Gunstfontein Wind Energy Facility and associated infrastructure, Northern Cape Province

Motivation for amendment of Environmental Authorisation

DEA Ref.: 14/12/16/3/3/2/826

July 2019

Figure 9.1: Updated wind farm layout with specialist environmental sensitivities (A3 Map included in **Appendix H**)

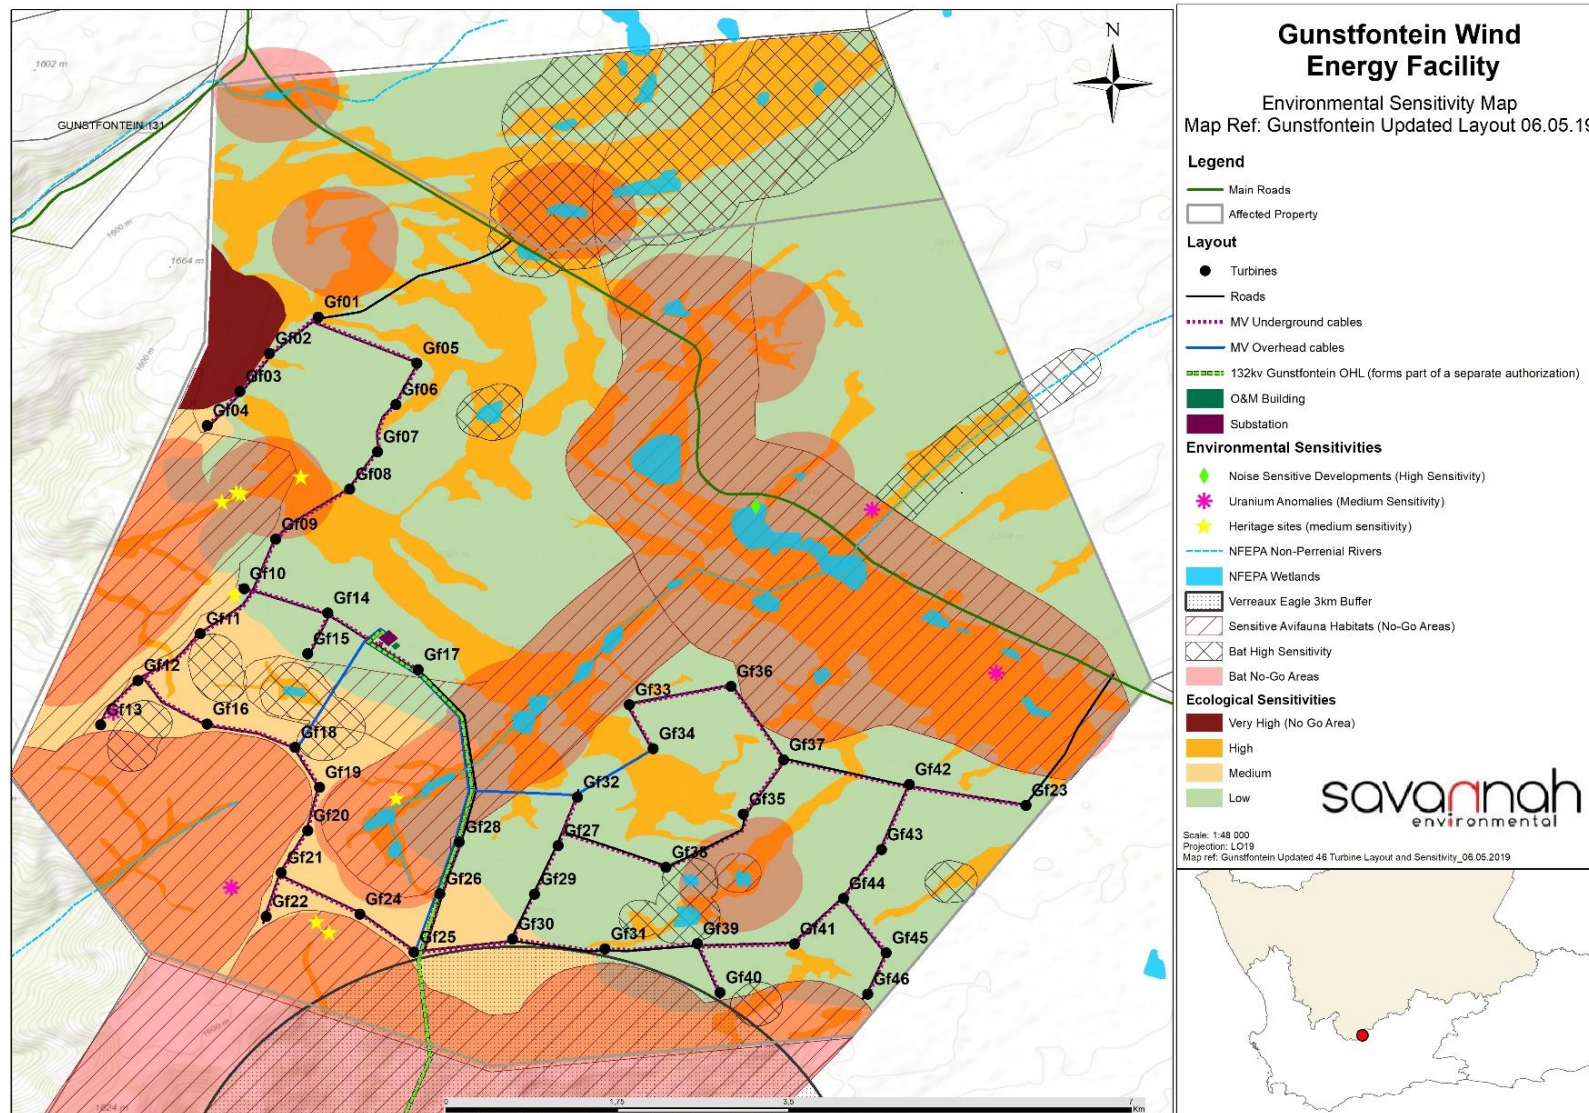
5. It is requested that the following conditions be removed from the Environmental Authorisation, since the numbering of turbines has been updated in the amended layout (as included within Figure 9.1 and Appendix H of this amendment motivation report) and the following conditions are no longer relevant (since the turbines have been renumbered from 1-46):
 - **Condition 2:** The following turbine positions are hereby approved, i.e. 1-13, 19-22, 25-29, 38-43, 48-54, 57-67
 - **Condition 3:** The following turbine positions is not approved; i.e. 14-18, 23, 24, 30-37, 44-47, 55, 56 and 68 and does not form part of the development
 - **Condition 41:** The underground MV line route linking turbine 40 to turbine 49 is not approved
 - **Condition 130:** The following turbine positions are hereby approved, i.e. 1-13, 19-22, 25-29, 38-43, 48-54, 57-67

- » No turbines may be located within the no-go areas, including the 3 km Verreaux's Eagle nest buffer (Figure 5.1 and 9.1). These no-go areas do not apply to associated infrastructure (this was confirmed with the avifaunal specialist).
